DISCUSSION of:

Ground Improvement Using Preloading with Prefabricated Vertical Drains

Bengt H. Fellenius, *Dr. Tech., P.Eng., Canada; email: bengt@fellenius.net*

Figure 1. Settlement measured at the benchmarks shifted 10 days.

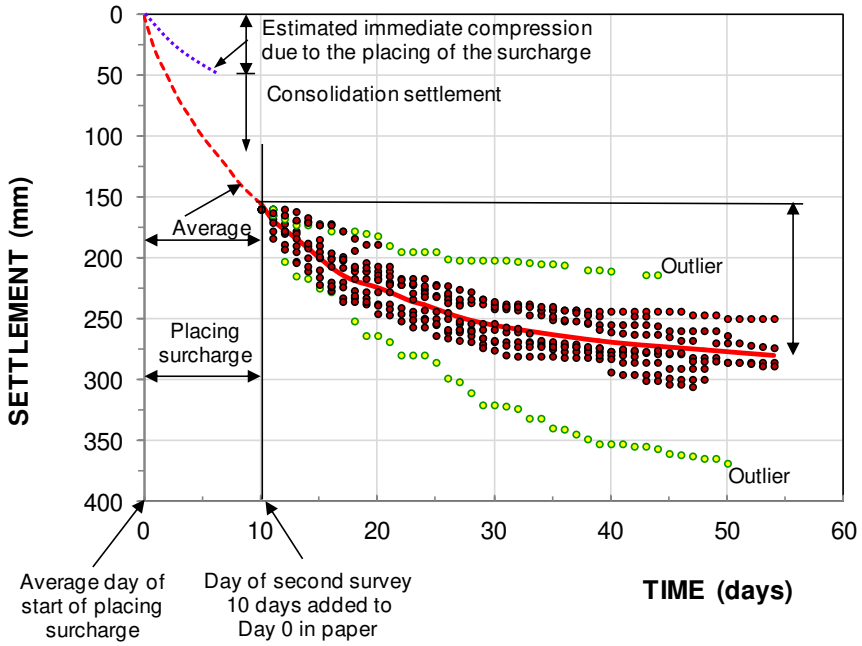
The authors report, that the first survey of the benchmarks was taken before the 3.0-m surcharge was placed across the test area. The first day of settlement measurements for the twelve benchmarks was the date of the second benchmark survey, which was carried out only when all of the surcharge had been placed to the full height over the test area. The time between the first and second surveys—and the placing of the surcharge—ranged from a few days to twenty days. Because the times between the placing of the surcharge and the second survey differed for the benchmarks, the amount of settlement that had occurred at the time of the second survey also differed between the benchmarks. This explains some of the significant scatter displayed in the authors' Figure 13. I have re-plotted the measured settlements in Figure 1 to a common starting point at the average start settlement of 160mm and added 10 days to the authors' measurement days to indicate the average duration of placing the surcharge, which took place before the second survey. During this time, immediate compression and some consolidation will have occurred. As indicated, I estimate the immediate compression to be about 50 mm. I have also added an average curve and extrapolated it back to the origin (the average excludes the two outlier records). All benchmarks appear to show that most of the consolidation had developed at the time the last survey was made.

Figure 2. Settlement measured at the benchmarks normalized to the average end values.

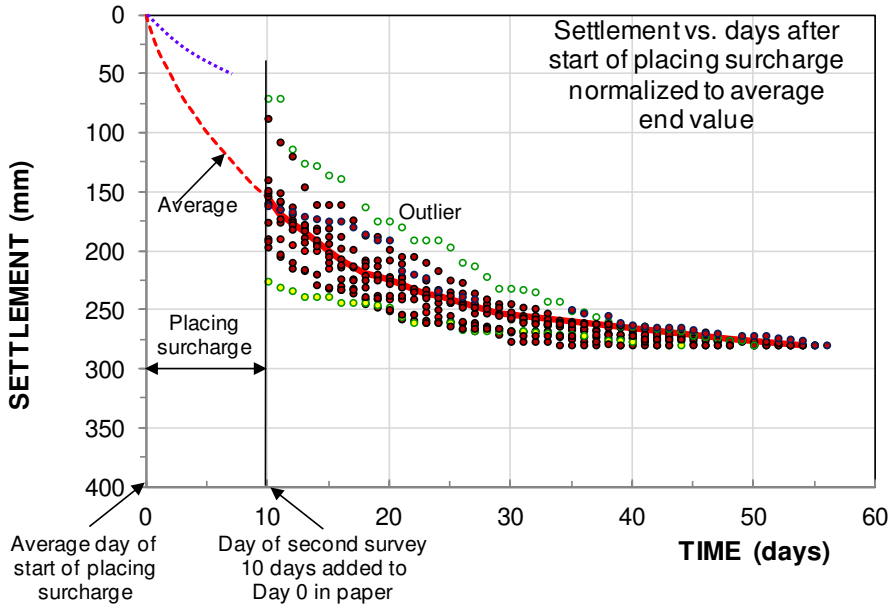
Figure 2 shows the measured final settlements are normalized to the average final settlement (280 mm). There is still much scatter between the curves, but now the approximate start date for each curve can be obtained by sliding the curves left or right until the best agreement to the average curve is obtained as shown in Figure 3. The removal of much of the scatter—the agreement between the time-settlement curves—is of course to some extent fictitious as the benchmark measurements cannot be expected to be all that similar; a natural variation must have taken place, not least with regard to the thickness of the soft clay layer. However, I believe that the figure suggests a reasonably realistic day for the start of placing the surcharge.

Figure 3. Settlement measured at the benchmarks adjusted to obtain the approximate start day.

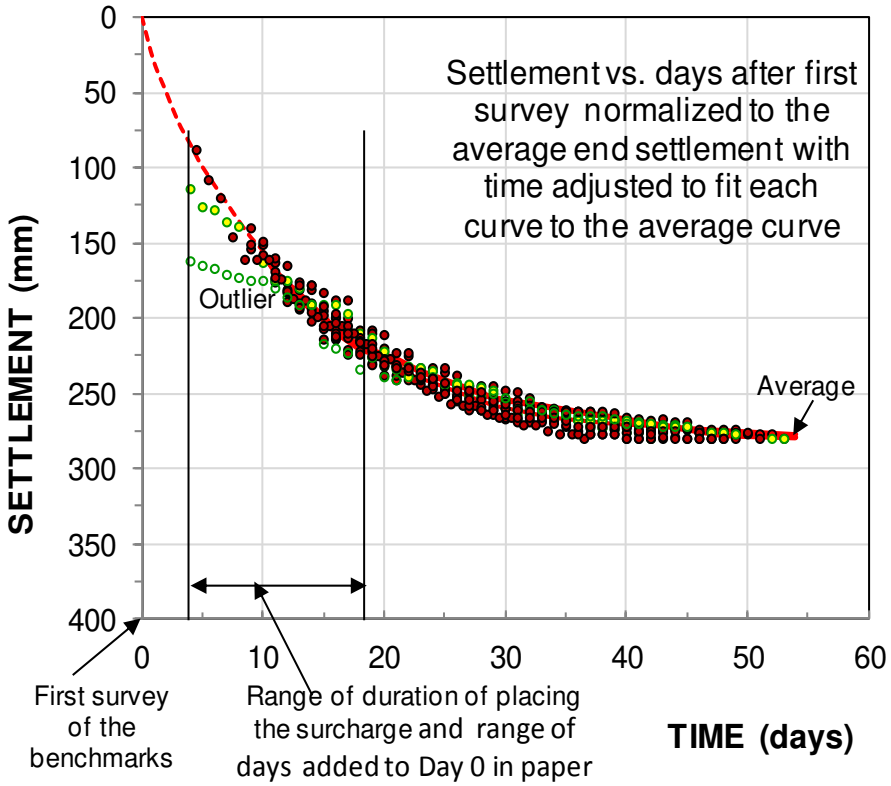
The average curve shown in Figure 3 can now serve as reference to a back-calculation of the time-settlement development for the wick-drain project to determine compressibility and coefficient of consolidation of the soil layers. The back-calculation consists of applying the theory of pore pressure dissipation in fine-grained soils (consolidation) due to radial flow (Barron 1948, Kjellman 1948, and Hansbo 1960; 1979) is based on radial flow toward a circular drain in the center of a cylinder of homogeneous soil with an impervious outer boundary surface). The theory is summarized in the Kjellman-Barron formula, Equation 1. The Kjellman-Barron formula is based on the assumption of horizontal (radial) flow only and a homogeneous soil.

Figure 4. Average measured and calculated settlements.

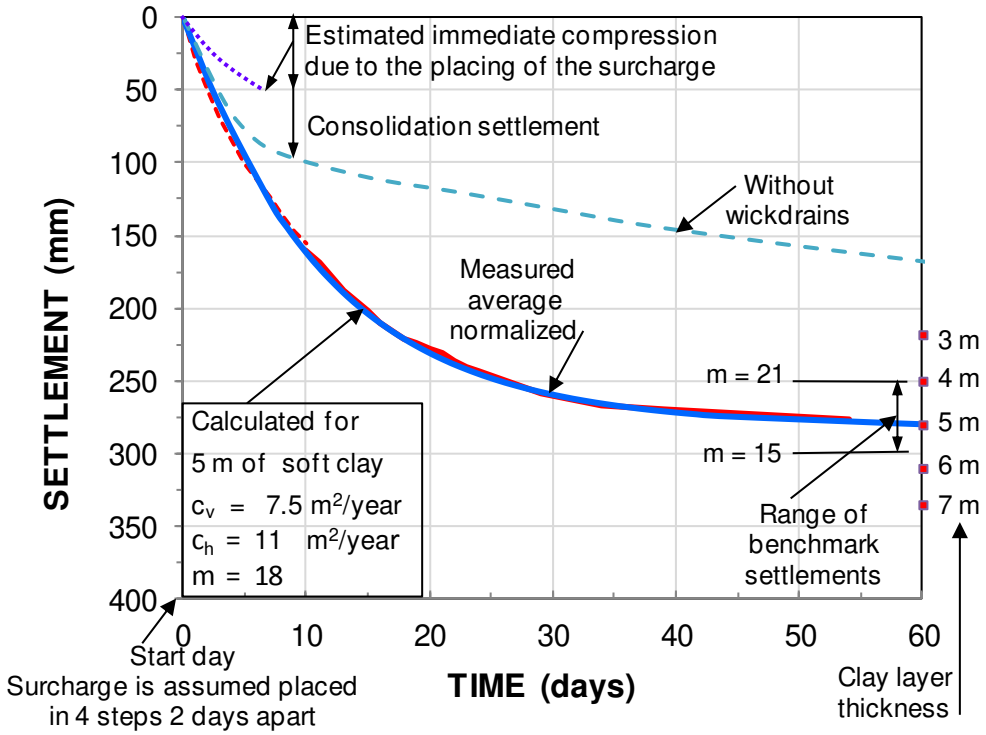
The results of the back calculation are shown in Figure 4 together with the average curve of the measurements. In order to show the sensitivity of the clay layer thickness and modulus number, the figure also shows the final settlement for soil layer thickness ranging from 3 through 7m and the final settlement resulting from modulus numbers of 15 and 21. The figure also shows the settlement during the first 60 days that would have occurred had there been no wick drains (for this input, I used the authors' 7. 5m^2/year c_v-coefficient).

Considering that my data reduction is quite different to that of the authors, my back-calculated c_h-coefficient (11m^2/year) agrees well with the authors' laboratory-established value (14m^2/year). The difference could be taken to represent the effect of a smear zone. However, considering all the uncertainties involved, I believe the agreement to be entirely fortuitous.
